REPORT / RECOMMENDATION

Subject: Sketch Plan Review – Bank of America, 6868 France Avenue.

Re: Sketch Plan Review – Bank of America (6868 France Ave.)

Subject: Bank of America: Edina Branch
Sketch Plan Review
Project Number: 21.9517.000

Rendering

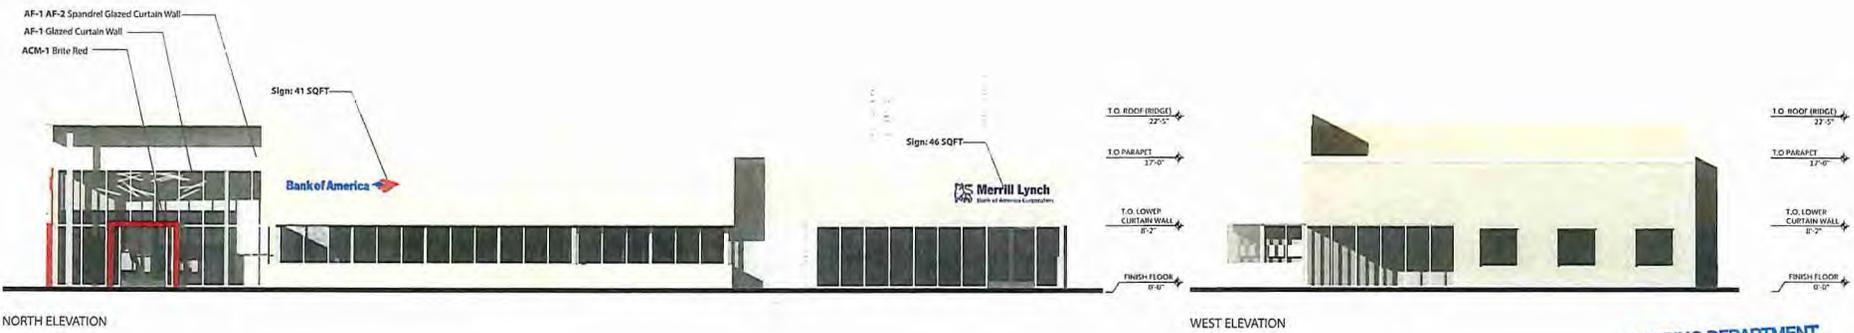
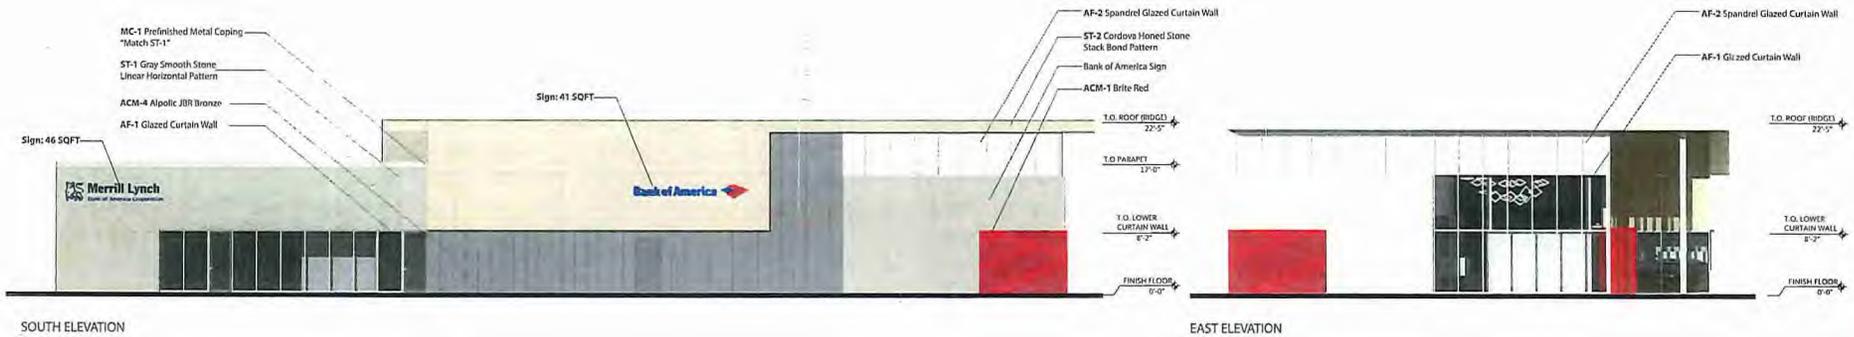
- Suggest four sided architecture; don’t want a “back of building” look.
- Suggest redesigning the building by implementing the guiding principles for the France Southdale area.

- Watershed district review. Review and approval of the Nine Mile Creek Watershed District is required.
- Building elevations. Building renderings and perspectives would need to be prepared to show what the building and drive-through would look like on the site from 69th Street and from France Avenue. Landscaping should also be included in the renderings.

- Building mass. The south side of the Bank of America facing the street has very few windows. Windows could be added to the break room to break up the mass of the building along the street.

L-1

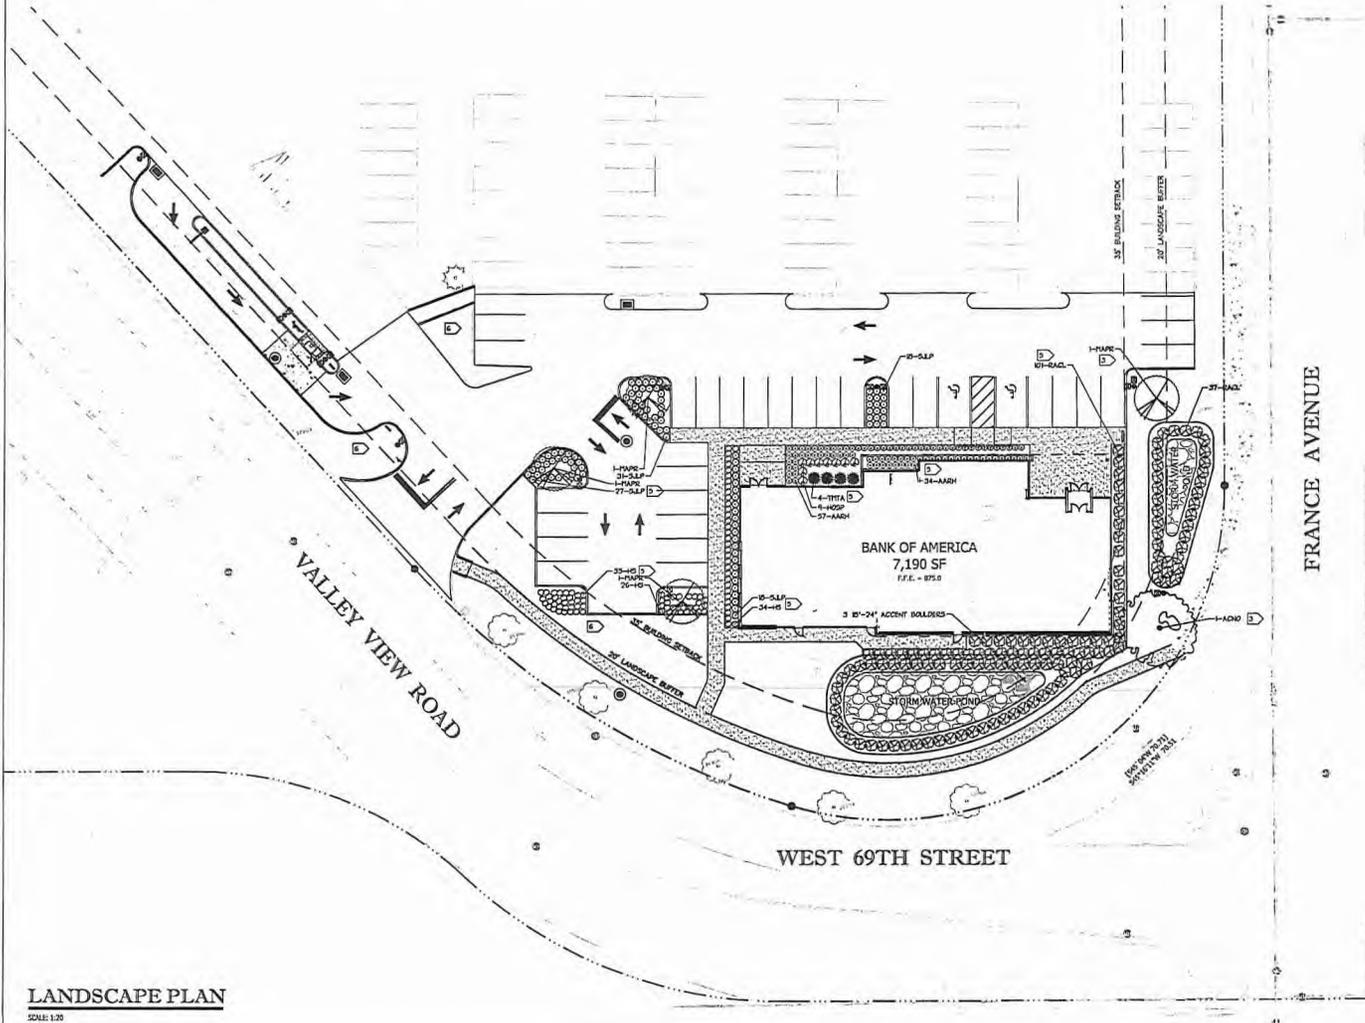
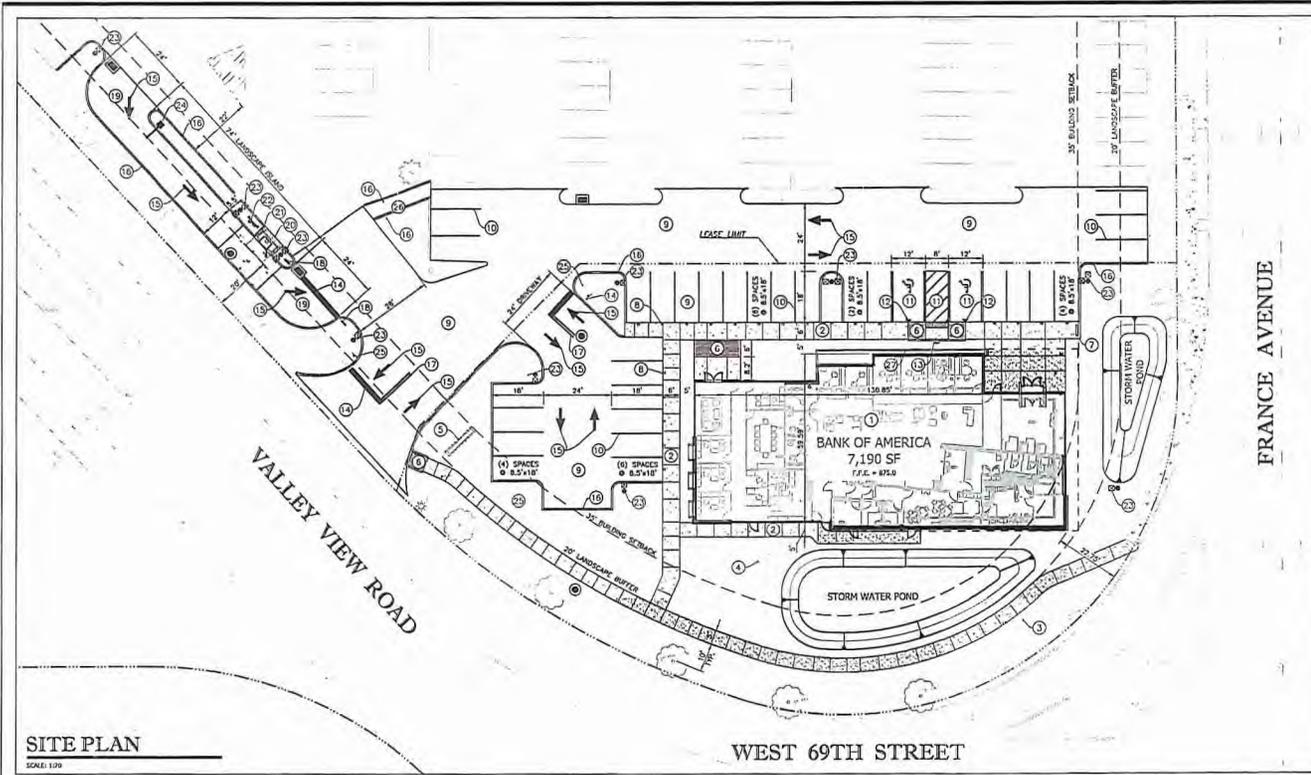
Commissioner Hobbs commented that he views the proposed rain gardens positively; however, encouraged planting more trees and proper grasses. Ms. Thomas responded they also felt the proposed rain gardens was positive, adding they will be working with an arborist on plantings and tree type. Thomas said a LEED certification also has specific landscaping requirements that need to be met.

- Add more landscaping elements to the site including the interior parking lot area.
- Engage the street. Consider ways to make this site better than the previous site.

C02.01

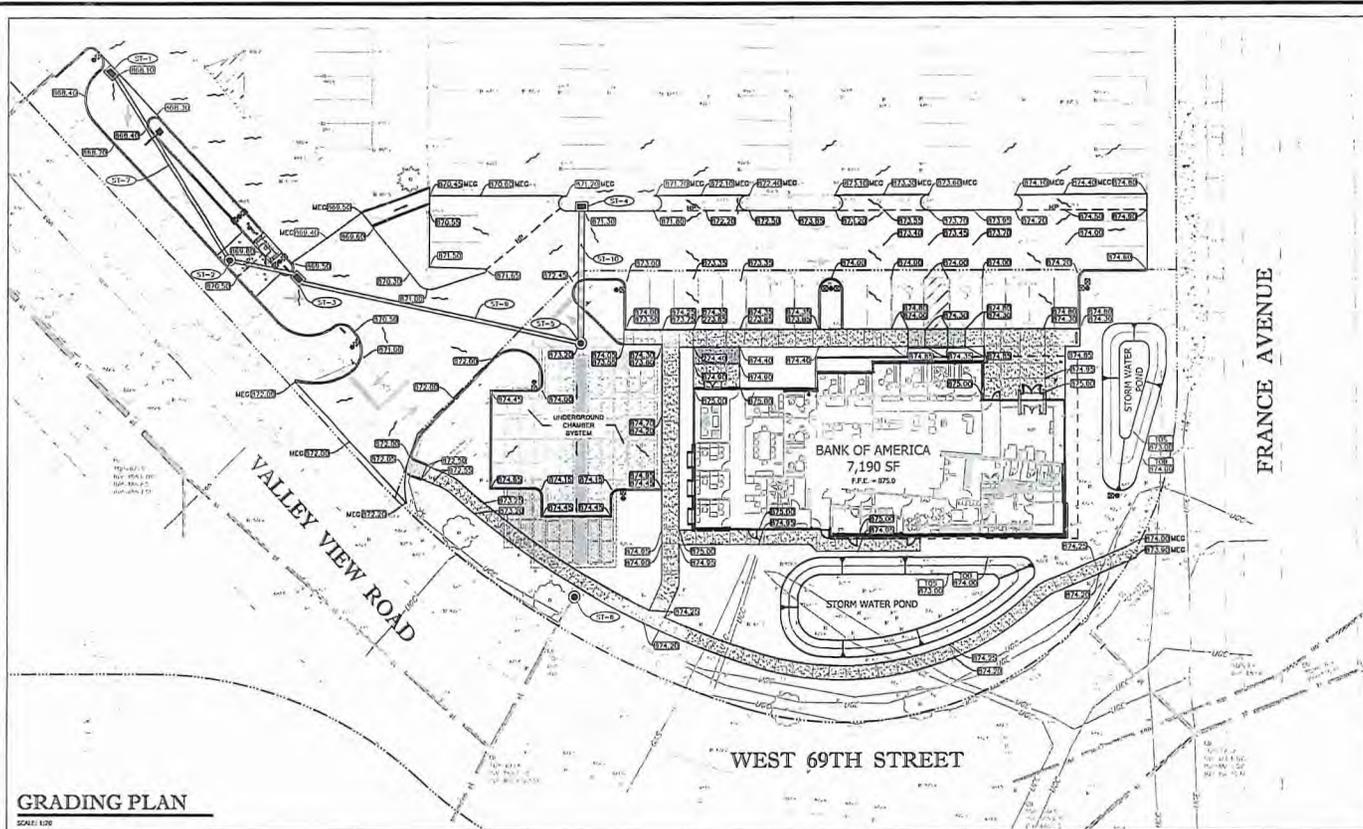
- Add more glass to the site; maybe through window placement.
- Consider this tract in its entirety; not only this specific area of the tract.
- Remove existing transformer.

- Street engagement. It appears there is only one door that opens to 69th on the Merrill Lynch side of the building. To justify any variances to bring the building up closer to the street, the applicant should demonstrate how they would meet the storefront or doorway principles from the Comprehensive Plan. (See page A14.)

- Sidewalk connections. The Bank of America side of the building does not have a sidewalk connection from France Avenue. The boulevard style sidewalk should be continued along France, and a connection to the front door from that sidewalk should be provided.

- Drive-through ATM. The location of the ATM drive-through adjacent to single-family homes is a concern. If this location is to be considered for variance, it should be heavily screened with year around landscaping.
